EXHIBIT "A"

**City of Mansfield
Amendments to the
2018 International Residential Code
North Central Texas Council of Governments Region**

***Figure R602.6.1; delete the figure and insert the following figure:*

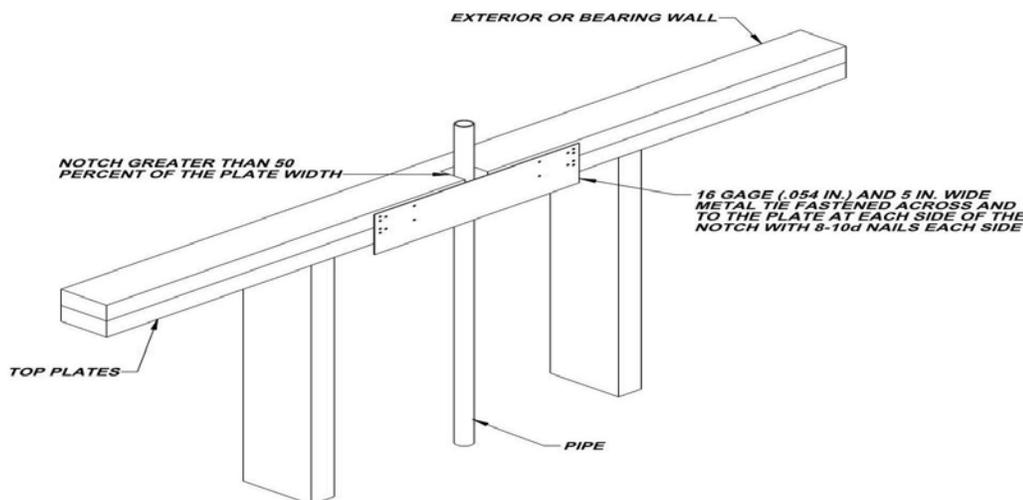
R602.6.1 Drilling and notching of top plate. When piping or ductwork is placed in or partly in an exterior wall or interior load-bearing wall, necessitating cutting, drilling or notching of the top plate by more than 50 percent of its width, a galvanized metal tie not less than 0.054 inch thick (16 Ga) and 4 ½ inches (38 mm) 5 inches (127 mm) wide shall be fastened across and to the plate at each side of the opening with not less than eight 10d (0.148 inch diameter) having a minimum length of 1 ½ inches (38 mm) at each side or equivalent. Fasteners will be offset to prevent splitting of the top plate material. The metal tie must extend a minimum of 6 inches past the opening. See figure R602.6.1. {remainder unchanged}

(Reason: Amendment to 2015 IRC carried forward to 2018 IRC. Also, provides additional assurance of maintaining the integrity of the framing by spreading the nailing pattern.)
